TOLEDO-LUCAS COUNTY PLAN COMMISSIONS

DATE: July 23, 2018 REF: PUD-4004-18

Request for an Amendment to a Planned Unit Development, originally granted by

Ord. 70-04, to develop multi-family units at 2757 Gardengate Place.

PLANNED UNIT DEVELOPMENT (PUD) REVISED SITE PLAN

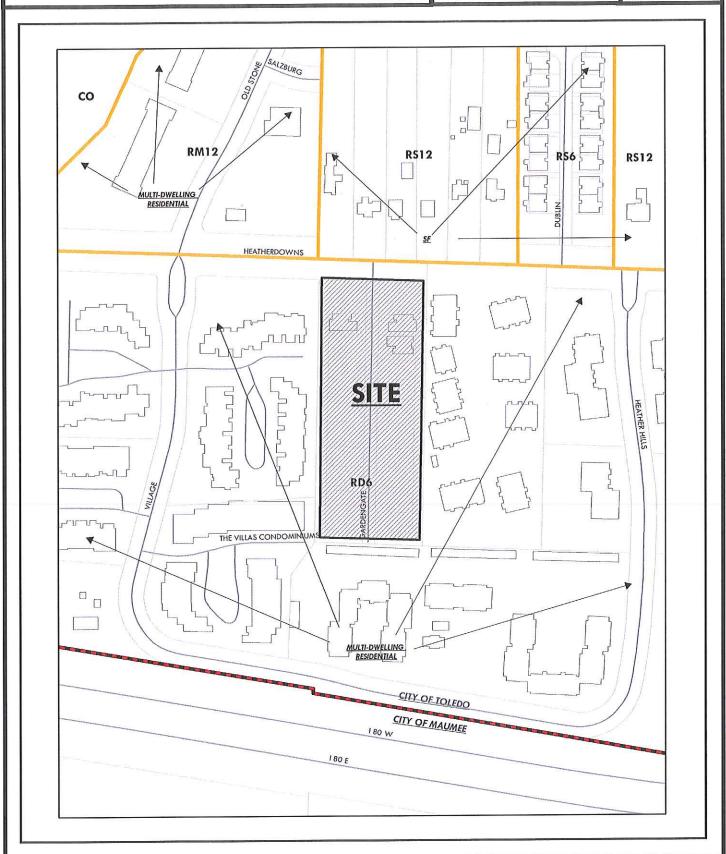
Pursuant to TMC1103.1007(C), no more than forty-percent (40%) of the gross site acreage shall be devoted to coverage by buildings, structures, street pavement, driveway and parking areas pavement. The existing CUP was approved with a total impervious surface area less than forty-percent (40%). However, the revised site plan submitted did not provide the percentages of the total impervious surface areas. Since the building footprints were modified from the previous approved CUP, the applicant shall submit a revised site plan with the percentage of gross site acreage devoted to impervious surfaces and listed as a condition of approval.

- 23. No more than forty-percent (40%) of the horizontal width of a street-facing facade on an attached house may be comprised of garage door area. All garage doors must be recessed at least four-feet (4') from the front building plane as stated in TMC§1105.0603(A & B). Applicant shall obtain a waiver for a 20% increase, to allow for 60% of the horizontal width of the façade to be comprised of the garage door area and for the garage doors to project beyond the front building plane.

- 24. A vehicle turnaround shall be provided at the end of Gardengate Place. Acceptable as depicted on revised site plan submitted on 6/18/2018.
- 25. Pursuant to TMC1103.1007(C), no more than forty-percent (40%) of the gross site acreage shall be devoted to coverage by buildings, structures, street pavement, driveway and parking area pavement. A revised site plan shall be submitted depicting the total area devoted to coverage by buildings, structures, street pavement, driveway and parking area pavement. Applicant shall obtain a waiver for a 6% increase, to allow 46% of the gross site acreage to be devoted to coverage by buildings, structures, street pavement, driveway and parking area pavement.
